Greater Sydney, Place and Infrastructure

IRF19/3798

Plan finalisation report

Local government area: Wollondilly

Figure 4: Proposed zoning and subdivision layout (Source: Proponent).

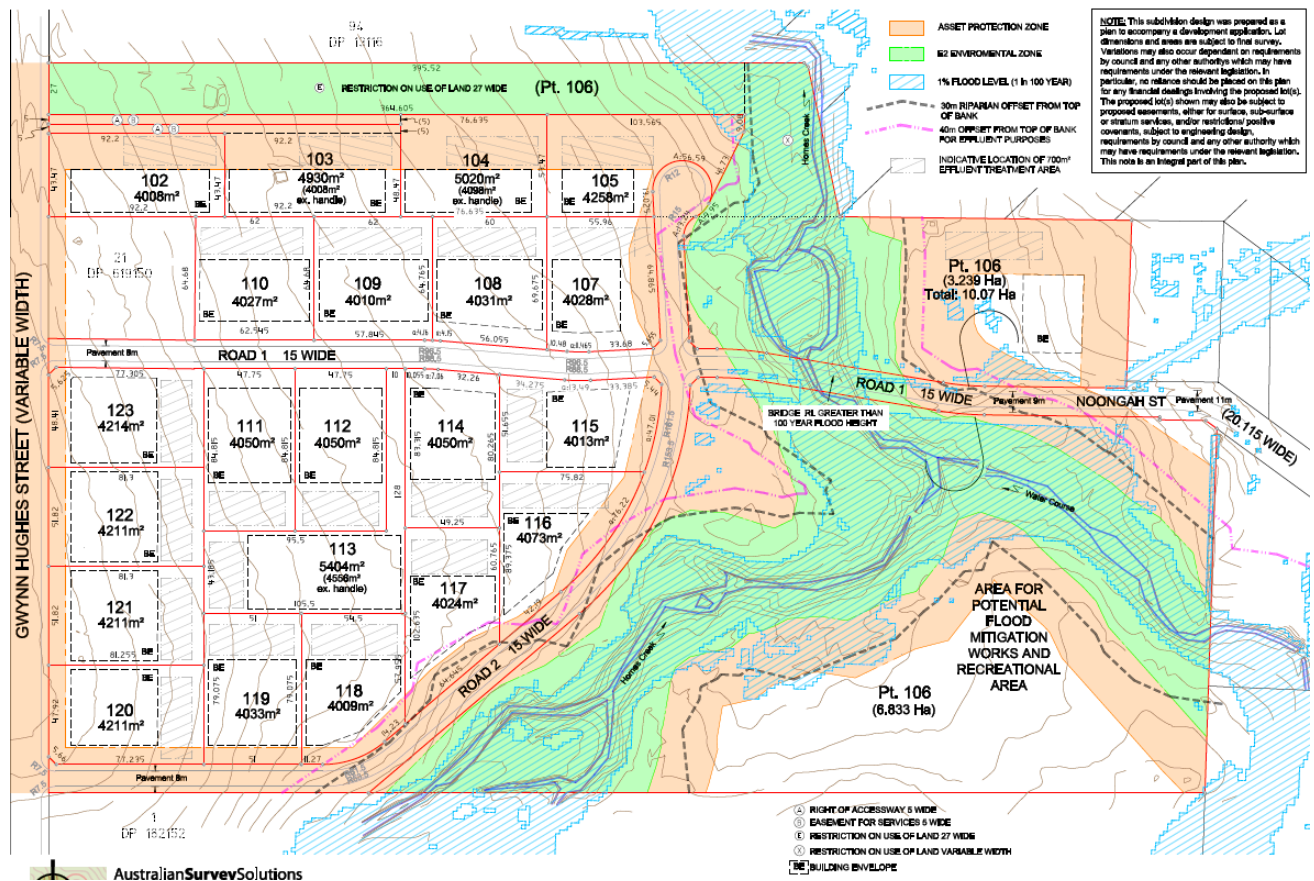
- future subdivision will locate effluent disposal fields immediately adjacent to the threatened *Grevillea parviflora* subsp. *parviflora* (Small-flower Grevillea) and *Persoonia bargoensis* flora species;

- Asset Protection Zones encroach and impact on vegetation identified as moderate ecological constraint;

- the proposed subdivision plan shows that the perimeter road and APZ are located within the riparian extent of Hornes Creek and does not appear to have been offset; and
- any biodiversity layer proposed to be applied to the site must include all high and moderate constraint areas.

The proponent's response and revised ecological assessment (**Attachment J2**) indicates support for E2 Environmental Conservation being contained within a single lot (lot 106), with any impacts to biodiversity values to be offset through the offsetting scheme under the *Biodiversity Conservation Act 2016*.

EES (**Attachment G1f**) reviewed the revised proposal and support the introduction of the E2 zone. EES advises potential impacts of clearing and indirect impacts (such as such as hydrological impacts, nutrient runoff and weed invasion) of effluent disposal fields to high/moderate ecological constraint vegetation, including SSTF, threatened flora species *Grevillea parviflora* subsp. *parviflora* (Small-flower Grevillea) and *Persoonia bargoensis*, and potential koala habitat, remain unaddressed.

The rezoning will permit effluent disposal fields, asset protection zones and building envelopes in areas considered to be of high biodiversity value.

There are several matters which have not been addressed. Without adequate measures to mitigate and offset impacts on threatened species, including SSTF (a CEEC) and potential koala habitat, the Department recommends the proposal should not proceed.

Figure 5: Existing vegetation types found on site.

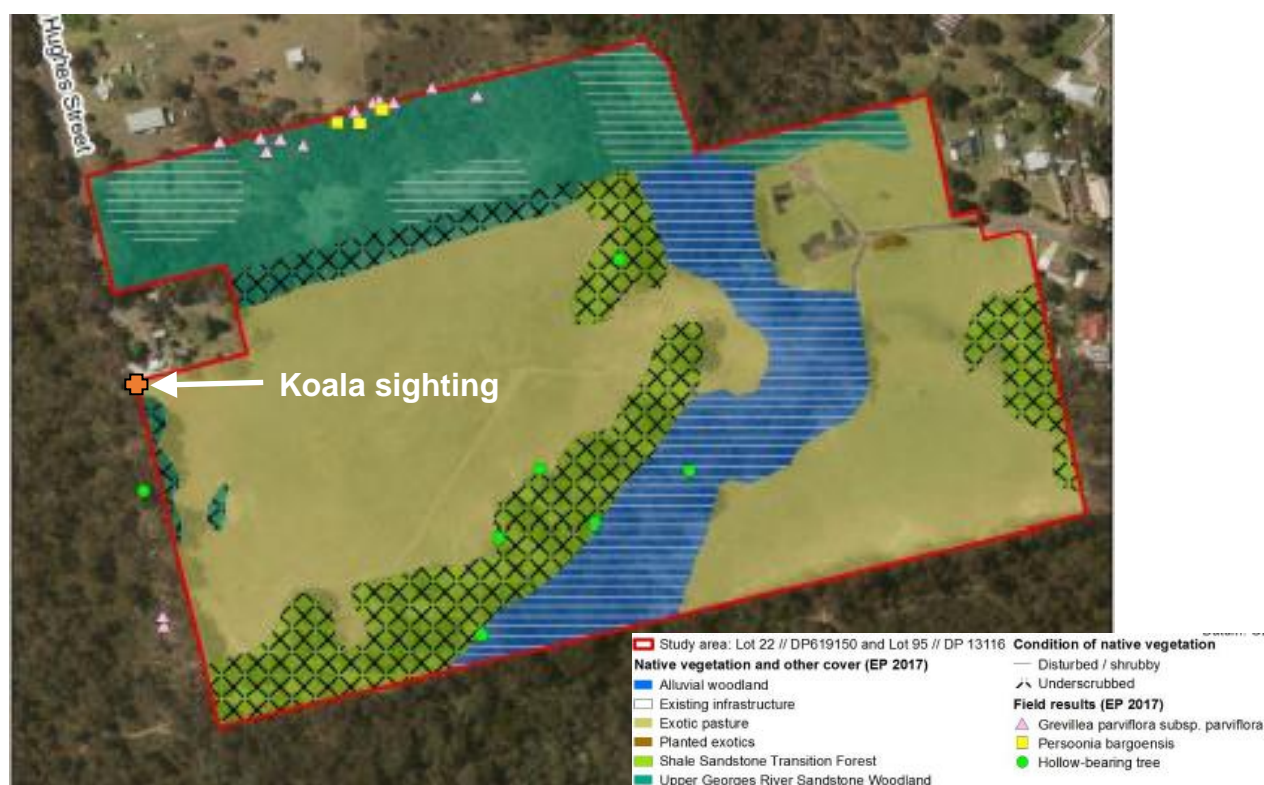
- impacts to native vegetation on the site, particularly high and moderate ecological constraint identified vegetation (Figure 5) should be avoided first by using prevention and mitigation measures, particularly as Shale Sandstone Transition Forest (SSTF) is a Critically Endangered Ecological Community (CEEC) and a large portion of the existing vegetation on the site is mapped as potential koala habitat;

- high ecological constraint vegetation along Hornes Creek and the northern boundary should be zoned E2 Environmental Conservation zone, rather than E3 Environmental Management or R5 Large Lot Residential;

- consideration should be given to ensuring high ecological constraint land is retained in a single parcel of land and managed in perpetuity under a biobanking agreement or via a community title scheme;

Figure 7: High (dark) and low (light) flood hazard levels affecting the site.

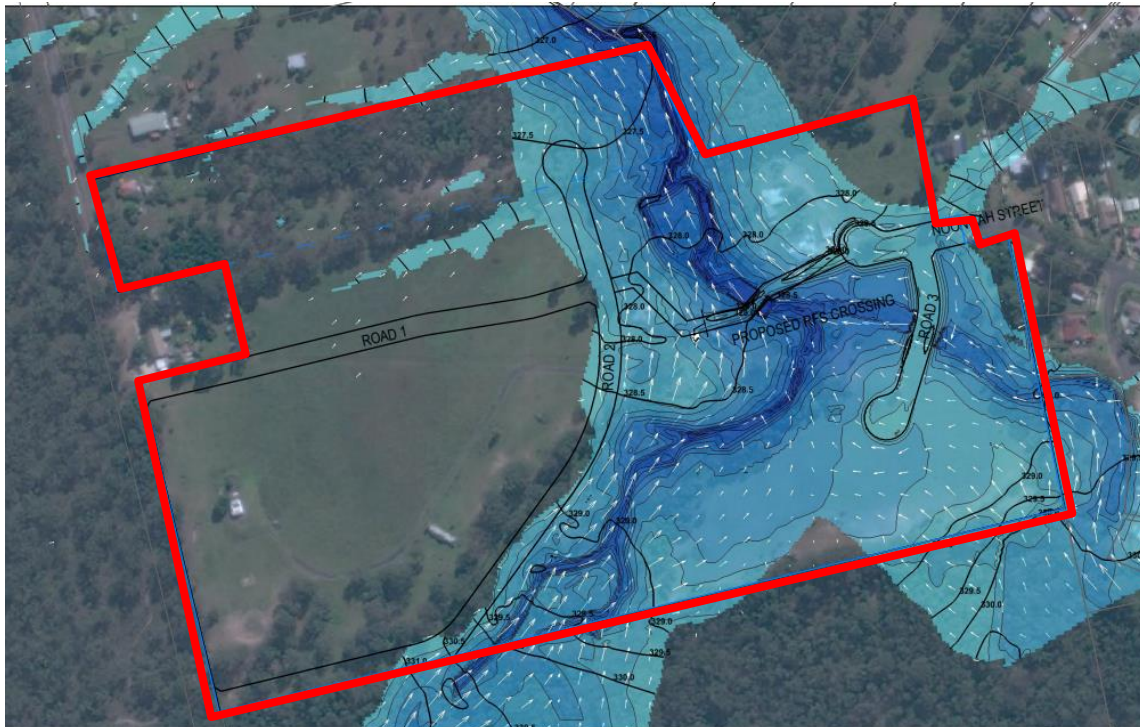
- the north-east side (along Noongah Street and proposed road 3) becomes isolated in the 1% AEP flood event which indicates no safe route is available;
- the south-east side along proposed road 3 has its access through Noongah Street cut off at 5% AEP which indicates that residents in the south-east area must evacuate in every flood event equal or larger than 5% AEP;
- the PMF scenario map shows the south-east area fully inundated in the PMF and EES supports Council's recommendation not to support the rezoning of the south-east area along Road 3;
- the flood immunity of the existing Kader Street Bridge (300m north of site) and the proposed river crossing at the end of Noongah Street has not been assessed; and

- the 1% AEP appears to encroach on proposed lots and new development should be above the 1% AEP plus 0.5m freeboard – this should be mapped, and level adhered to as minimum floor levels for any future development.

- the 1% AEP flood modelling identifies impacts on existing residential areas upstream on the eastern stream and any road access across the creek would necessitate filling and potentially increasing the upstream flood levels – as such the rezoning of the central/south eastern portion of the site should not proceed;

- the north-east portion of the site may be suitable for rezoning but EES' concerns about this part of the site must be addressed;
- access to the remaining two portions of residential development would be separated by the riparian corridor (a shared path link across with low flood immunity would be acceptable) with vehicle access from either side – so the flood immunity of the existing Kader St Bridge needs to be assessed and upgrading considered if appropriate;

The proponent responded to the flooding concerns raised by EES, Council and SES, by removing the residential lots on the eastern portion of the site and proposed emergency egress access to Noongah Street (**Attachment J1**). The proponent considers the northeast of the site is not flood affected and could be used for a childcare facility.

EES (**Attachment G1f**) reviewed the changes and supports the removal of the proposed lots and the preparation of an amended flood assessment to assess the proposed works and impacts on the flood planning level. EES do not support a childcare facility in the northeast corner of the site unless management measures are set in place to ensure access to this area.

- the development only provides for evacuation offsite up to the 1% AEP and has not considered off site evacuation up to the PMF;
- the proposed shelter-in-place for flood events exceeding the 1% AEP should not be supported due to the risk to life posed by those sheltering in place trapped by high hazard flood waters;
- absence of modelling to demonstrate the impact of the bridge structure on the 1% AEP flood behaviour or events larger than the 1% AEP – the bridge structure may impact proposed lots located near the creek/proposed road; and
- the response does not outline the rate of rise of the creek, provide any information on time to evacuate, or how long the persons to the west of the creek are likely to be trapped.

The proposal has not satisfactorily addressed impacts on the flooding behaviour in the area and the potential risk to life presented by the proposed flood evacuation over Hornes Creek. The Department recommends the proposal should not proceed.

Figure 9: Proposed RFS Egress Crossing

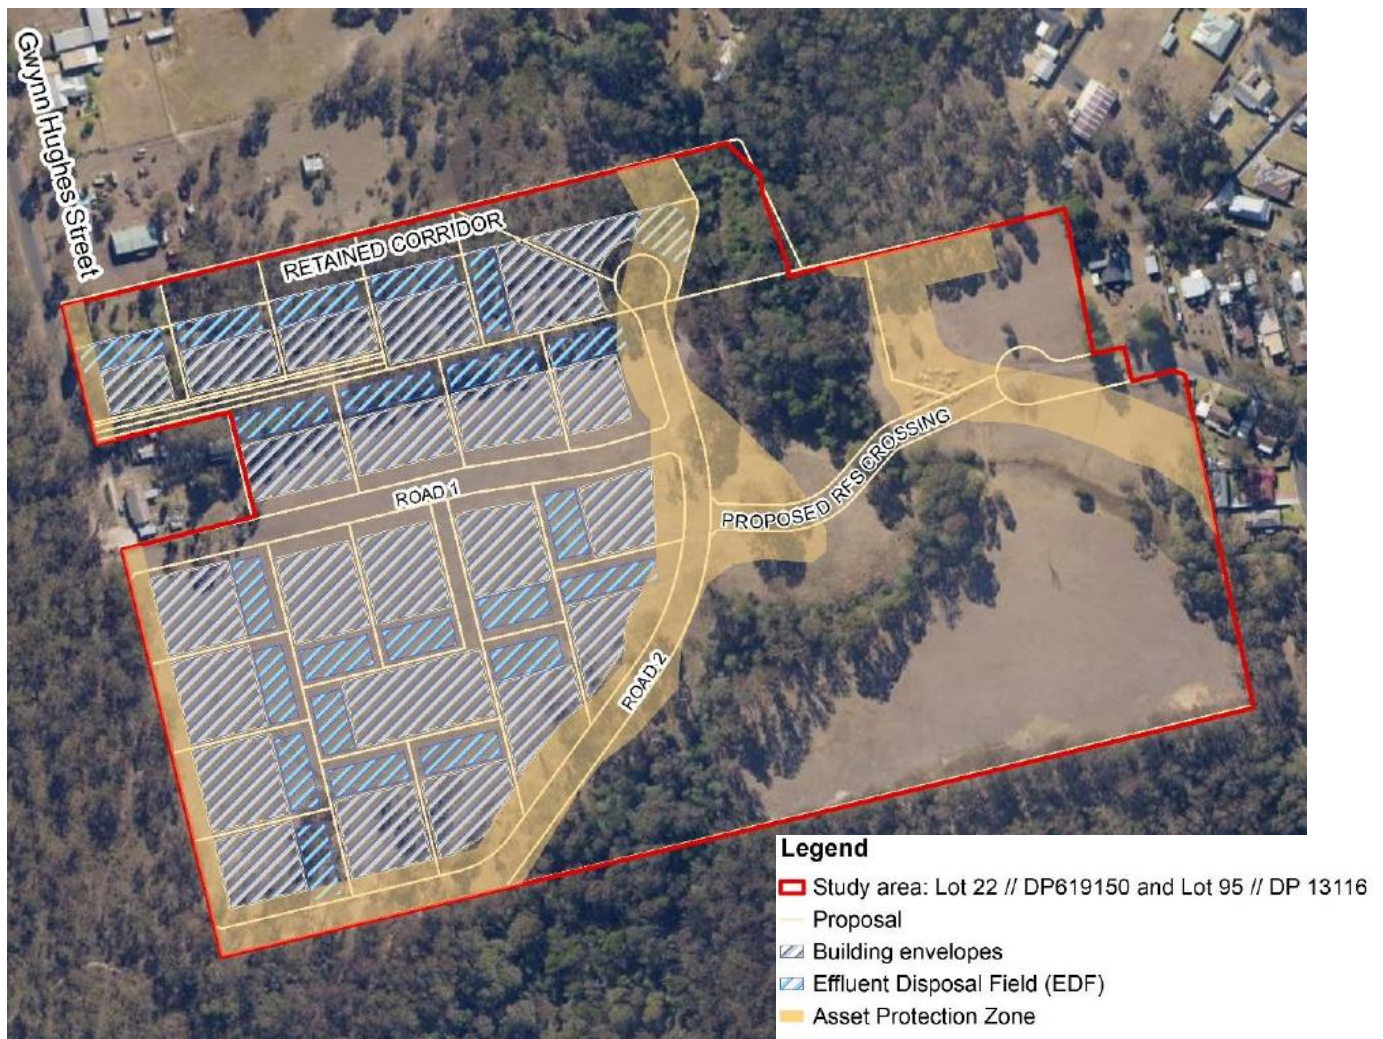
The RFS comments from 2018 advised that prior to progression of the proposal Council should be satisfied that the linking road:

- can be constructed to the standards of a public road in accordance with *Planning for Bushfire Protection 2006* (PBP);
- can be ungated to allow unimpeded egress for future residents evacuating in the event of a bushfire emergency; and
- construction of the road includes suitable flood immunity.

Council (**Attachment I**) noted that the proposed gated fire trail raises potential access issues in the case of emergency. Further, the cumulative flood and bushfire impacts, particularly in cases of emergency make the proposal undesirable.

The proponent noted that the RFS did not object to the proposal and advised that the updated proposal includes an egress road from Gwynn Hughes Street to Noongah Street which is designed to public road standards (i.e. unimpeded) and increased the APZ widths to comply with PBP.

The Department notes that *Planning for Bush Fire Protection 2019* is the relevant current standard for the proposal to meet.

As noted above, there are flooding impacts associated with the construction of an egress road/bridge over Hornes Creek therefore it may not be achievable to address bushfire evacuation.

The proposal has not addressed the potential risk to life and impacts on flooding behaviour in the area by the proposed bushfire evacuation over Hornes Creek and in its current form, the Department recommends the proposal should not proceed.
